**Report: TAB REPORT**  
**Function: Test, Adjust, & Balance**  
**Date: 05/31/2023**

**PROJECT**  
**05-29-23 CULVERS - GRAIN VALLEY, MO**

## **Issue List**

**Issue Name :** 2. RTU-2 Diffuser 2-16 Low on Airflow, Damper Inaccessible

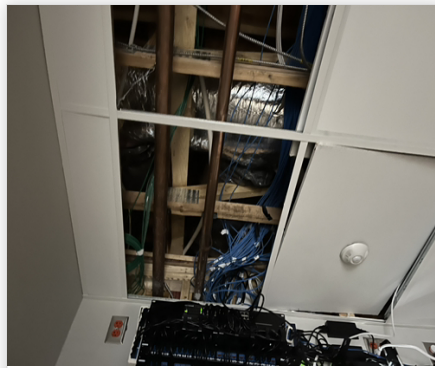
**Description :** Diffuser 2-16 on the GRD for the electrical room is very low on flow at 124/600 CFM. This value hasn't changed with moving air around which implies the damper is closed at takeoff. Tech is unable to reach takeoff to check for a damper due to ceiling restrictions.
